STATE OF NORTH CAROLINA
DEPARTMENT OF TRANSPORTATION

Subject: **Modification Request for Section 404 Individual Permit, Section 401 Water Quality Certification and Neuse Riparian Buffer Authorization** for Interstate 40 Widening and Improvements from I-440/US 64 (Exit 301) to just north of SR 1525 (Cornwallis Road), including improvements to NC 42 and SR 1010 (Cleveland Road) in Wake and Johnston Counties, Federal Aid Project No. IMNHF-040-4(139)301; TIP Numbers I-5111 and I-4739, Divisions 4 & 5; Debit \$570 from WBS Element 42346.3.1.

It has come to our attention that several wetland and riparian buffer impact areas require revisions. The buffer areas were visited in the field by staff from NCDOT, RK&K, and S.T. Wooten on December 2, 2019. These issues have been brought to your and Mr. Rob Riding's attention by Division 5 staff. Attached are revised permit drawings depicting the affected areas, all of which have a revision date of 12/12/2019.

LOCATION: I-40 FROM I-440 /US 64 (EXIT 301) TO JUST NORTH OF SR 1525 (CORNWALLIS ROAD), INCLUDING IMPROVEMENTS TO NC 42 AND SR 1010 (CLEVELAND ROAD).

PERMIT DRAWING
SHEET 92 OF 125
ENGLISH

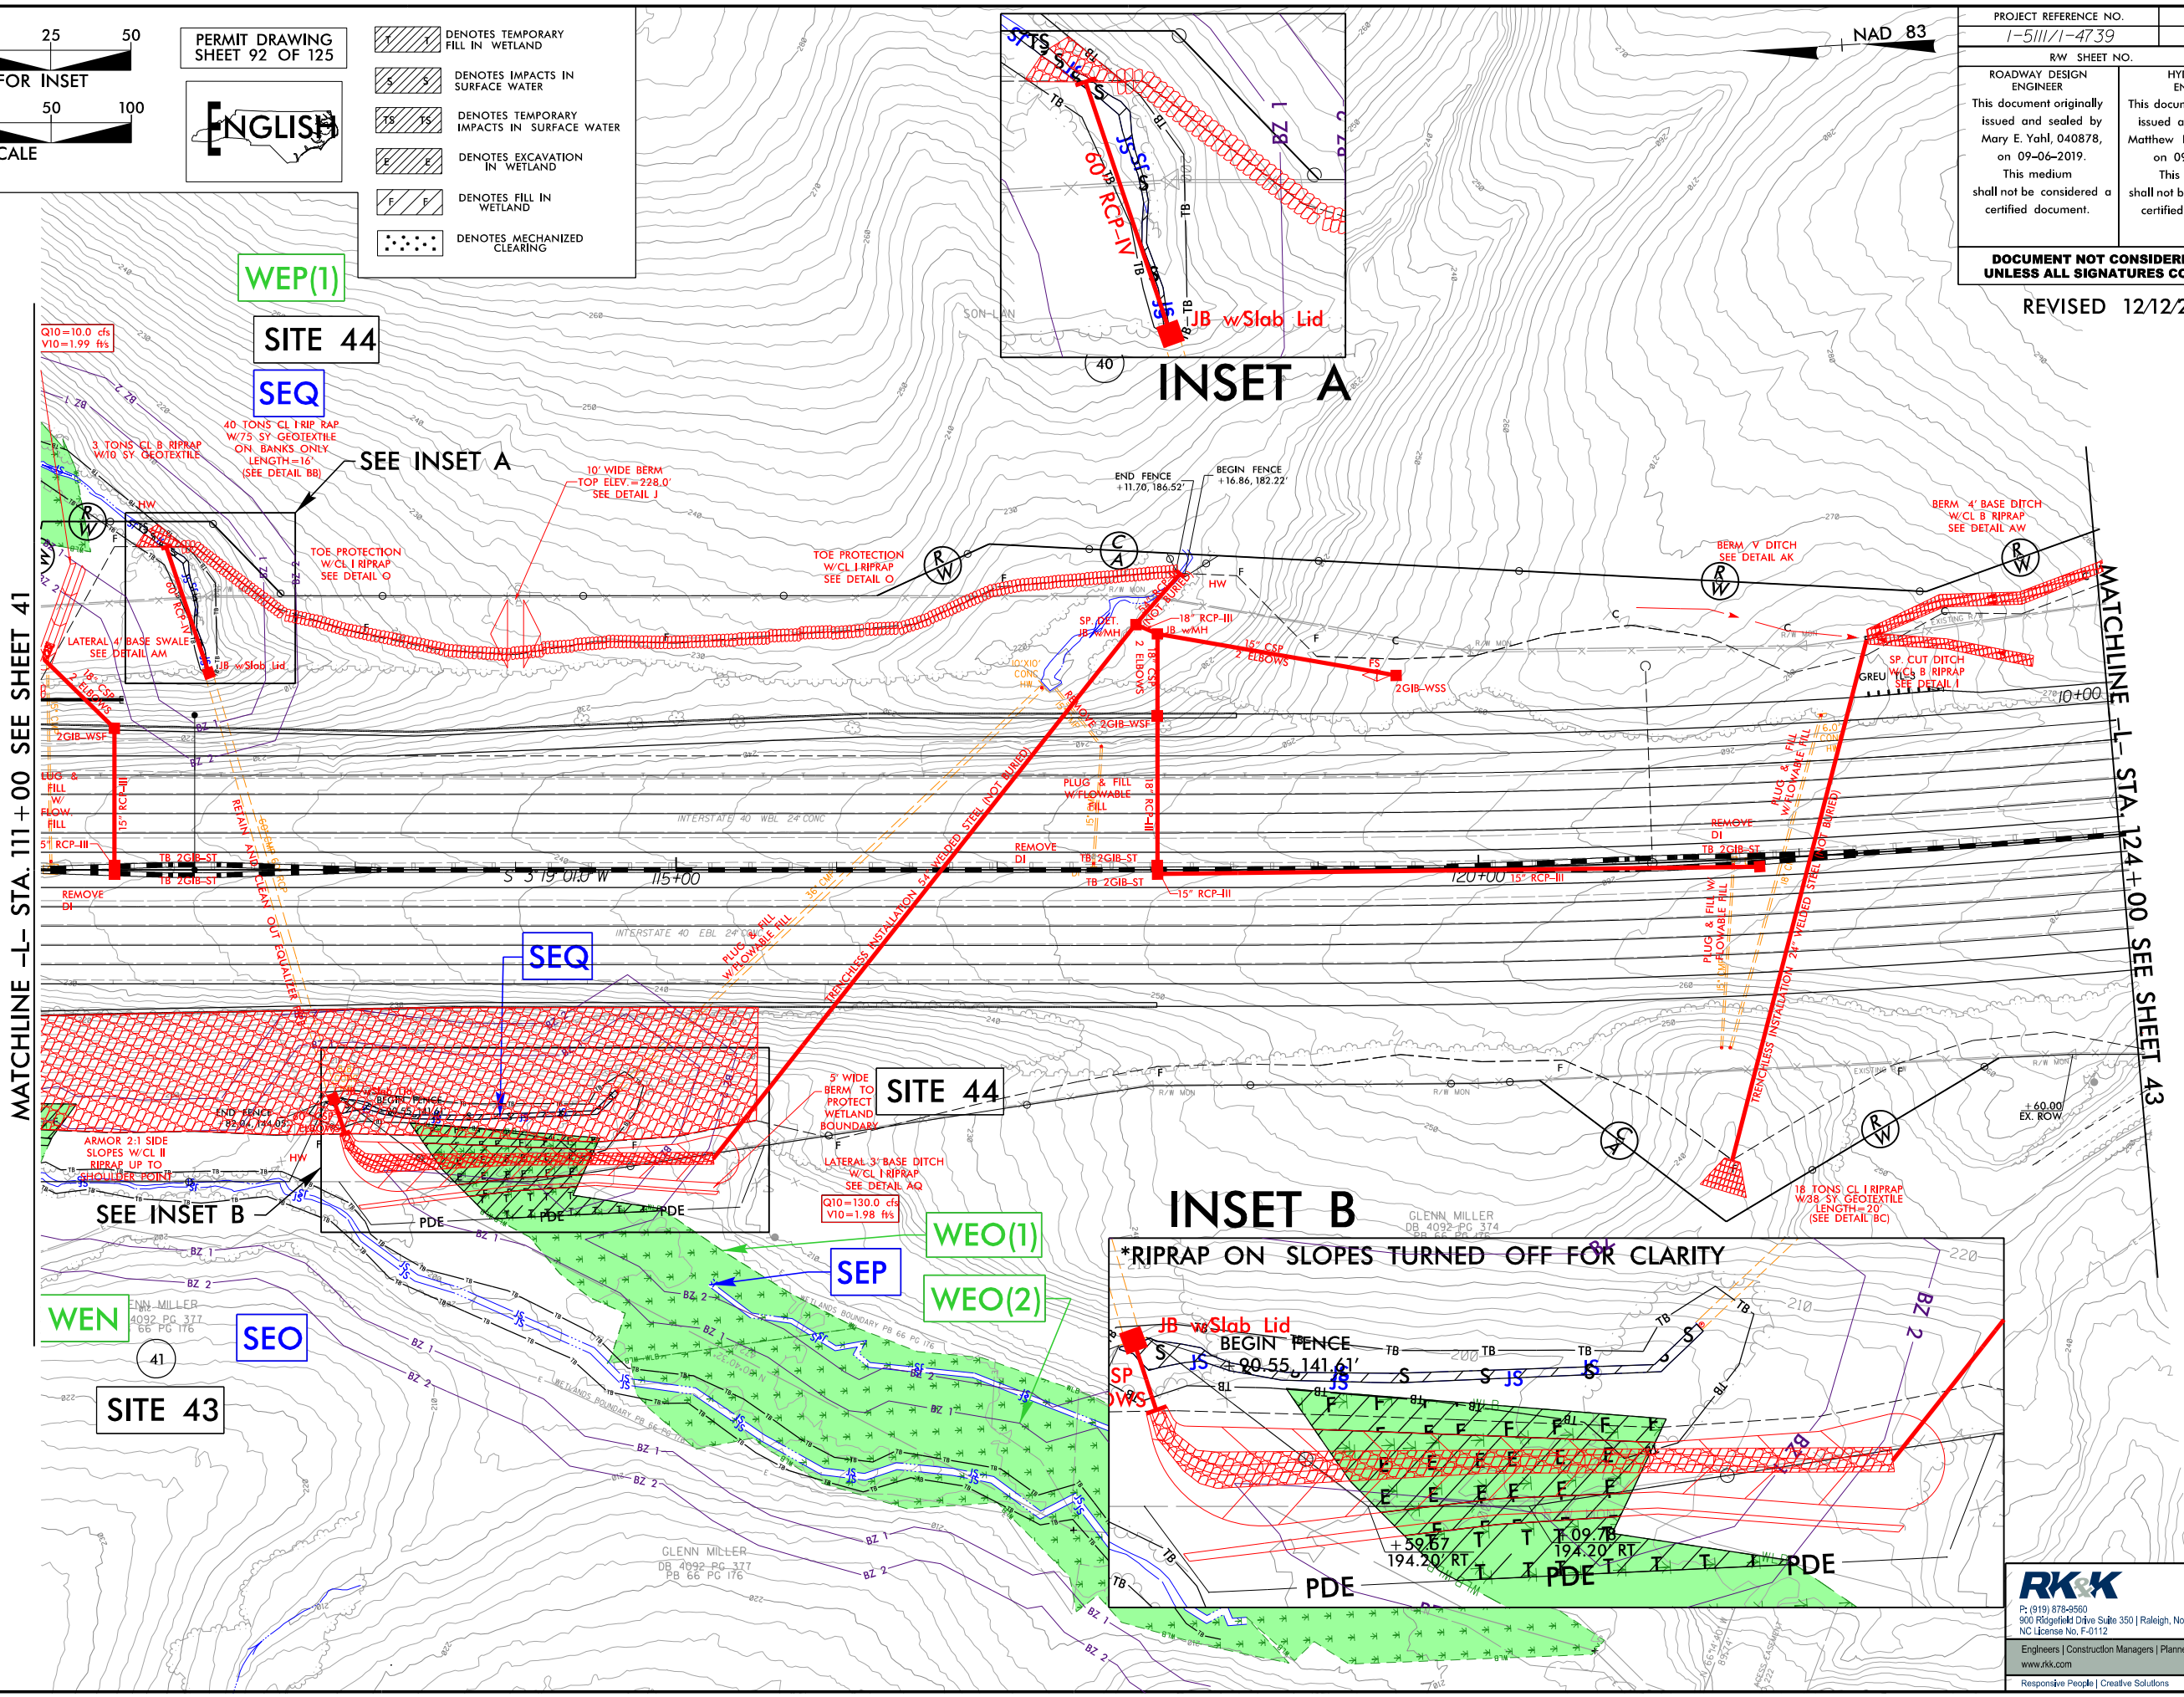
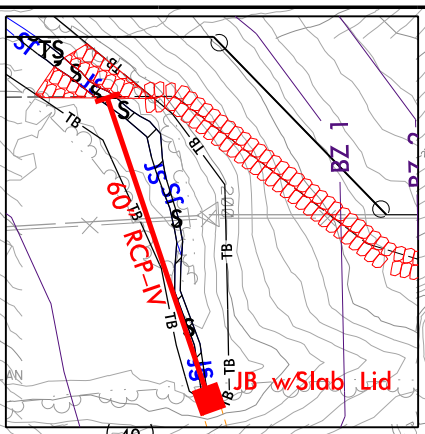
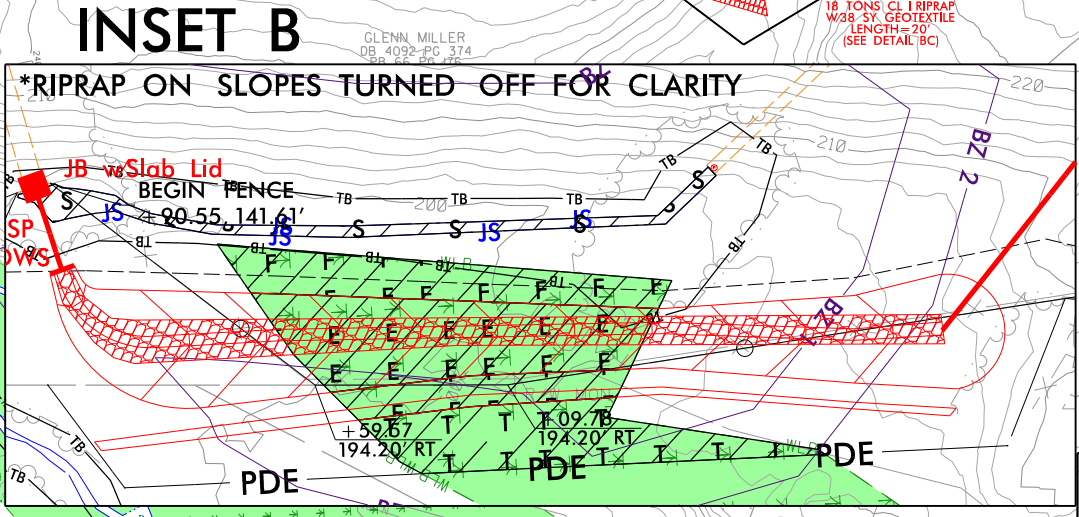
3. Site 42, -L- 106+38 – 111+14 RT will change a portion of the mechanized clearing to permanent fill in wetland. This is due to a Geotech recommendation to push riprap into the soft soils 12” – 24” deep in the area of the wetland. This limits the amount of undercutting that will need to occur. The Geotech recommendation states the station range is appr. -L- 110+00 – 125+00. The actual impacts due to the wetland shape are in the station range -L- 106+38 – 111+14. (There is a portion of temporary fill in wetland that will change to permanent fill in wetland, 0.002 ac, but it is so small that it is lost due to rounding). We do not anticipate a draining effect on the wetlands. The relocated channel will serve to function like the stream we are removing (SDN). There will be no voids in the riprap that is installed therefore we do not anticipate a discharge. Soil will be prevalent throughout the riprap.

- Permit drawing 91 of 125: plansheet 42 reflecting revisions to Site 42
- Permit drawing 92 of 125: plansheet 42 reflecting revisions to Site 42
- Site 42: previous permanent fill in wetland: 0.23ac, previous mechanized clearing: 0.10 ac; new permanent fill in wetland: 0.29 ac, new mechanized clearing: 0.05 ac (note that rounding with all project impacts makes the total project increase in permanent fill in wetland 0.05 ac and the decrease in mechanized clearing 0.05 ac).

BUFFER DRAWING SHEET 23 OF 52

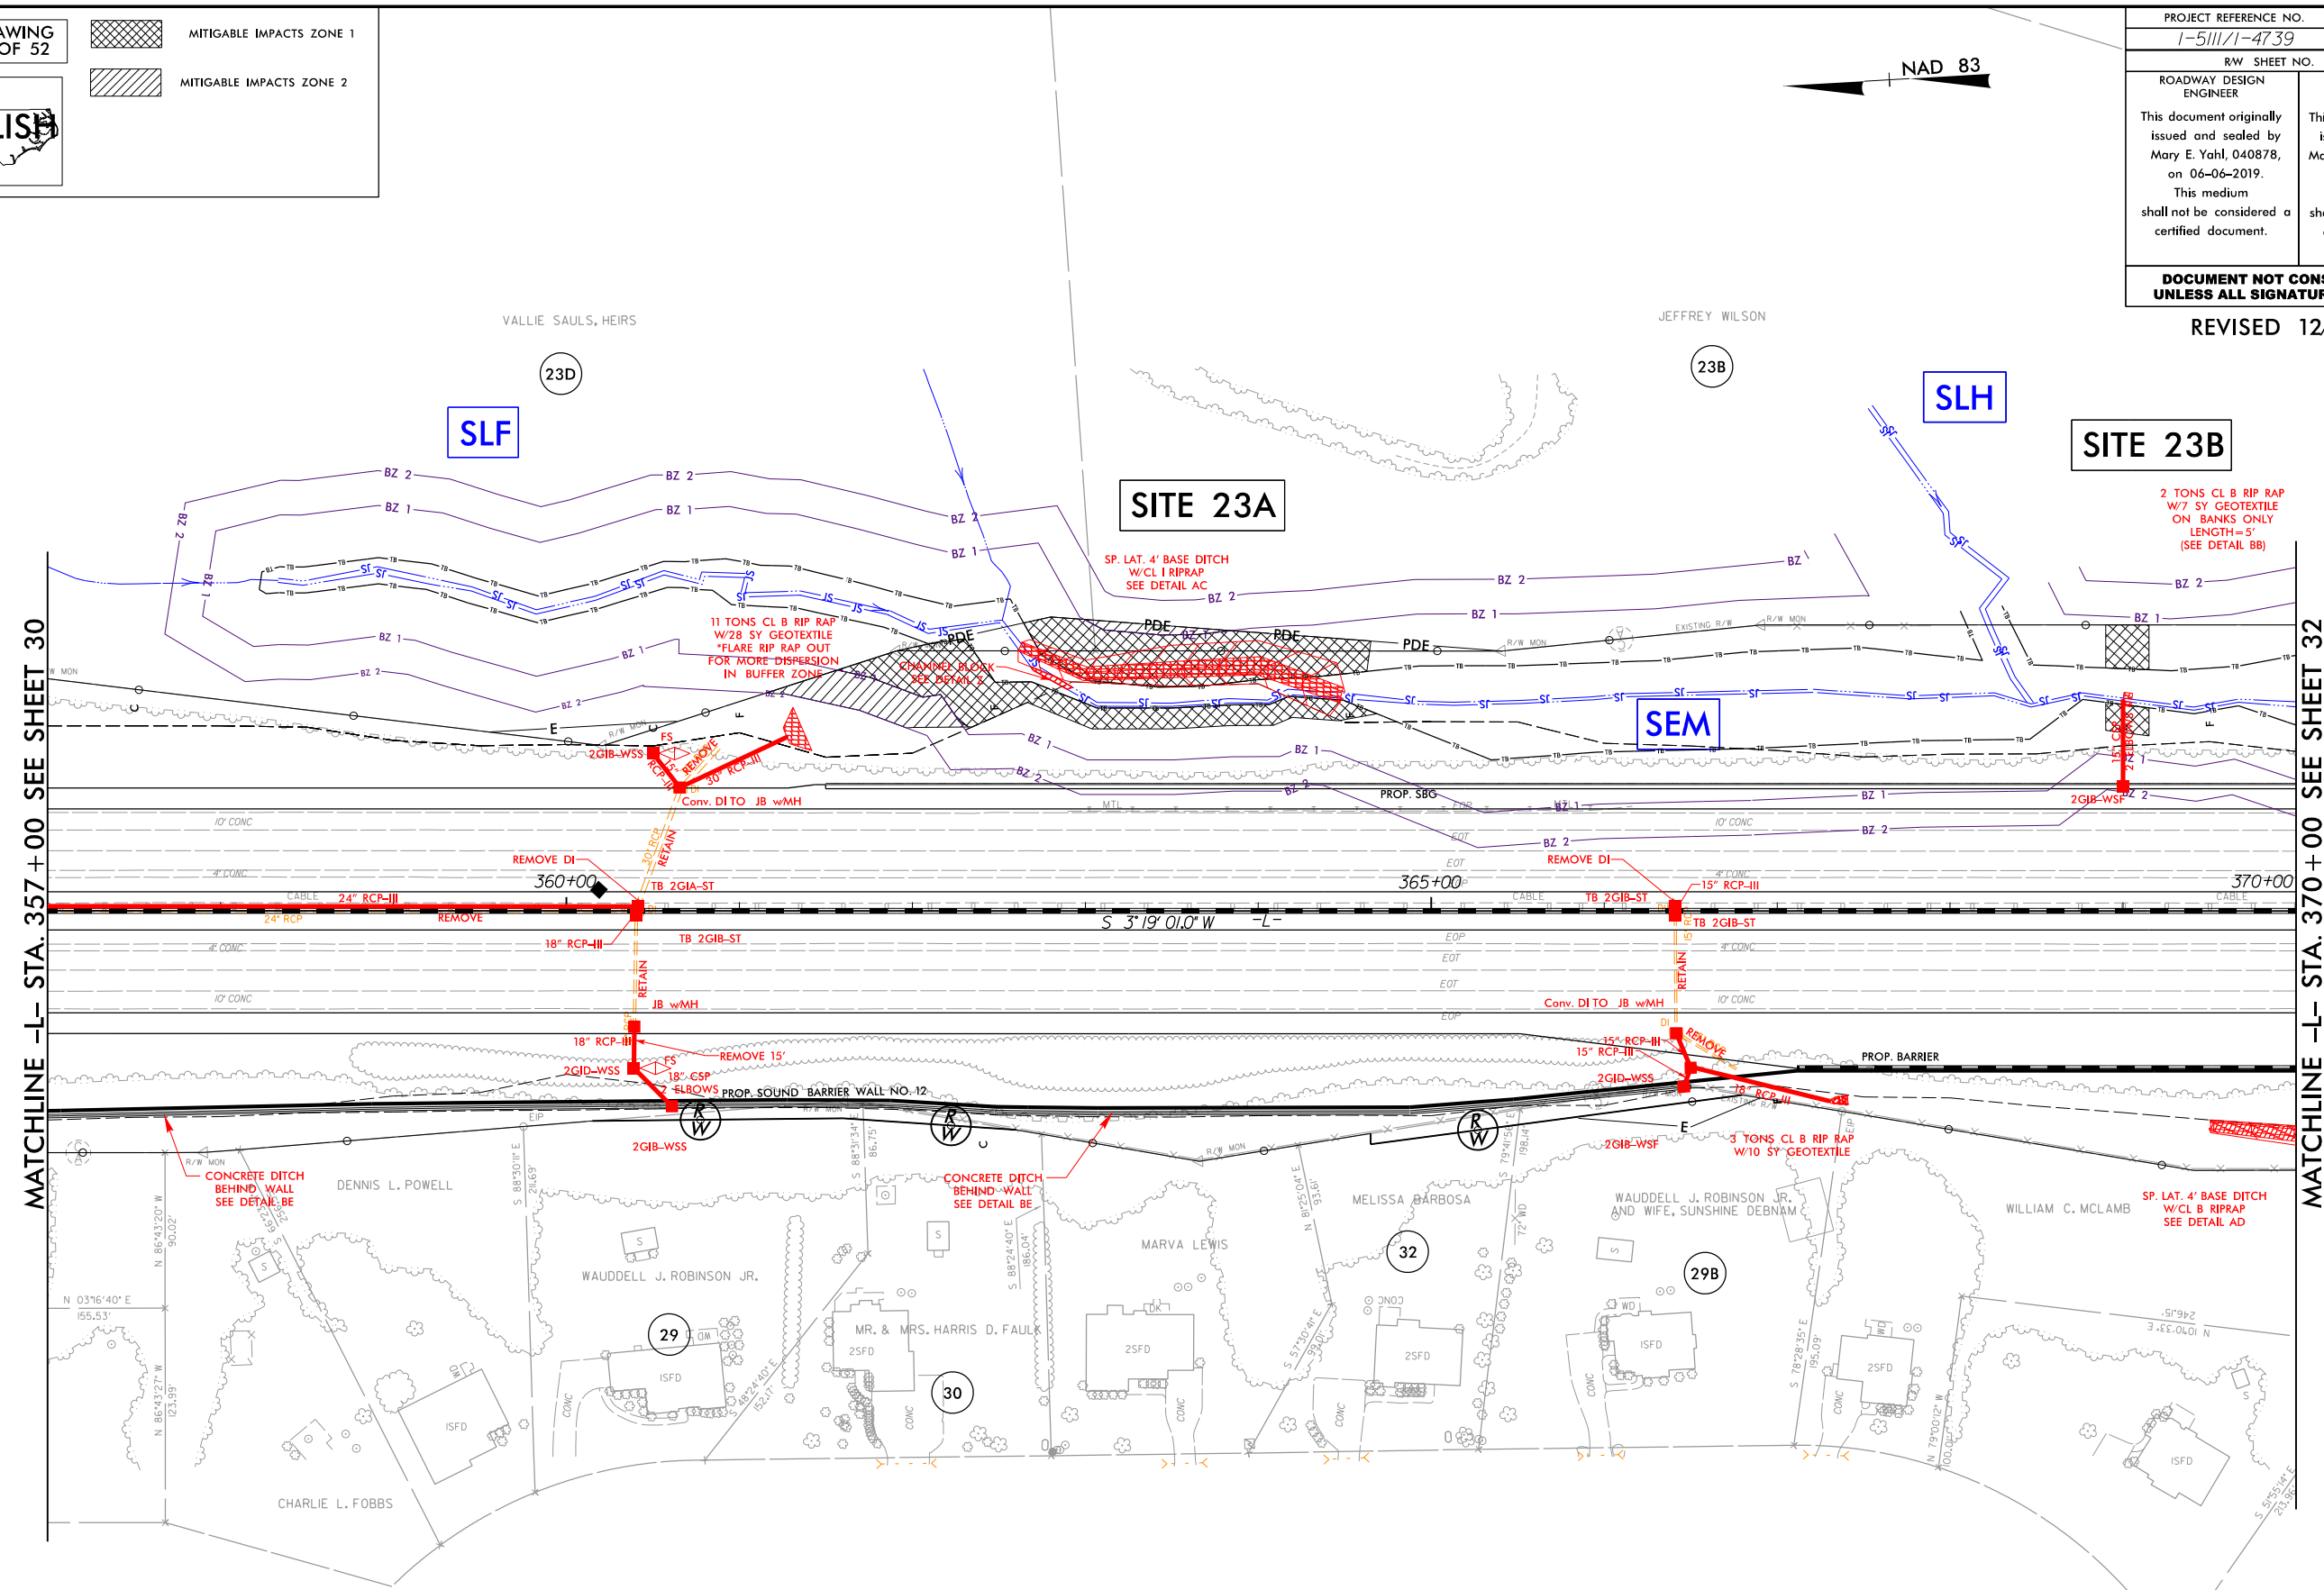
1. Additional buffer impacts at Sites 23A, 23B, and 26A. These revisions reflect additional impacts to mitigable buffer zone 1 areas that the Division requested after field reviewing the top of banks and edge of transportation facility areas at each location. (This information was previously submitted to DWR before the other issues came to light).
2. Changing temporary impacts along the upstream, right bank of Swift Creek, Site 40, to permanent impacts by lining the bank with Class II riprap. This is considered a permanent

Specially for item 1, the buffer impacts, these revisions reflect additional impacts to mitigable Buffer Zone 1 areas following Division 5 staff field reviewing of the top of banks and edge of transportation facility areas at each location. The following sheets have been modified:

- Site 23A: previous mitigable zone 1 impact total: 8,260 sq. ft.; new mitigable zone 1 impact total: 10,192 sq. ft. (difference of 1932 sq. ft.)
- Site 23B: previous mitigable zone 1 impact total: 635 sq. ft.; new mitigable zone 1 impact total: 1,037 sq. ft. (difference of 402 sq. ft.)
- Site 26A: previous mitigable zone 1 impact total: 233 sq. ft.; new mitigable zone 1 impact total: 422 sq. ft. (difference of 189 sq. ft.)
- Overall total project previous mitigable zone 1 impact total: 299,329 sq. ft.; new mitigable zone 1 impact total: 301,854 sq. ft. (difference of 2,525 sq. ft.)
